ADDENDUM

Project: Camp Shawnee Eating Shelters

Addendum No.: 03

Date: October 20, 2025

**G SPOT FOOTING W/ PIER FOOTING
OPTION A**

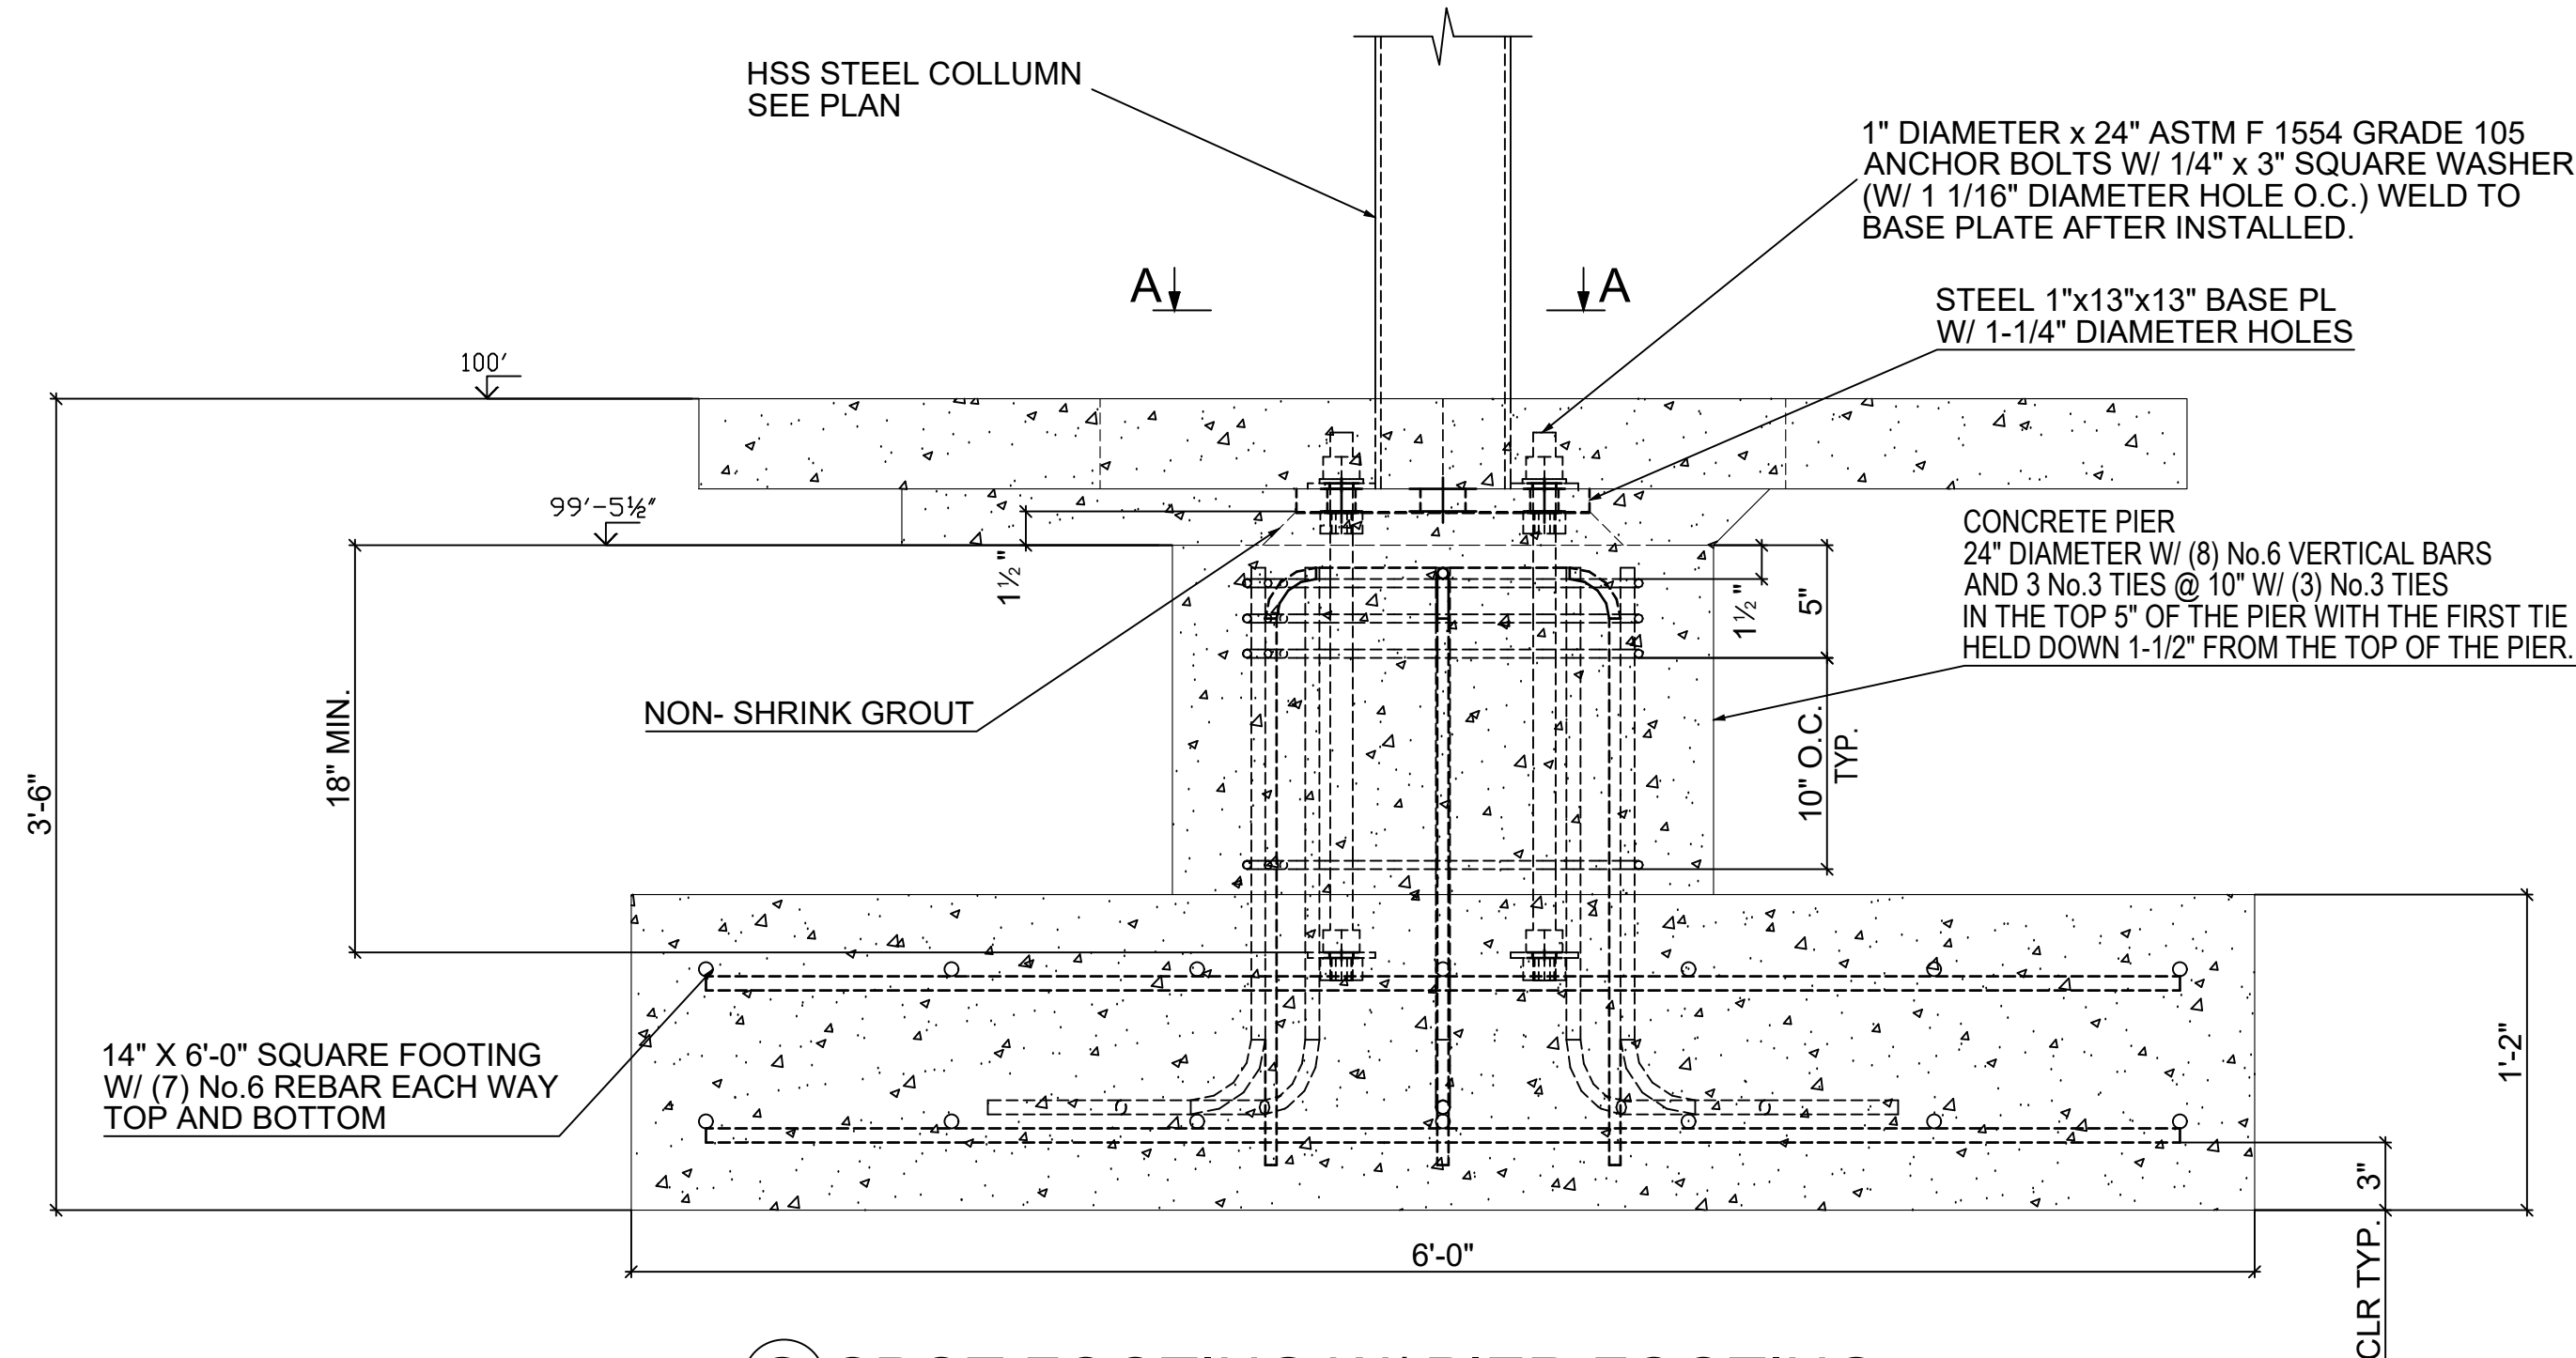
1. Changes to prior Addenda:
 - a. None
2. Changes to Bidding Requirements:
 - a. None
3. Changes to Conditions of the Contract:
 - a. None
4. Changes to Specifications:
 - a. None
5. Changes to Drawings:
 - a. C811-C813 Pavilion
See the attached revised drawings for changes to the concrete and reinforcing requirements.
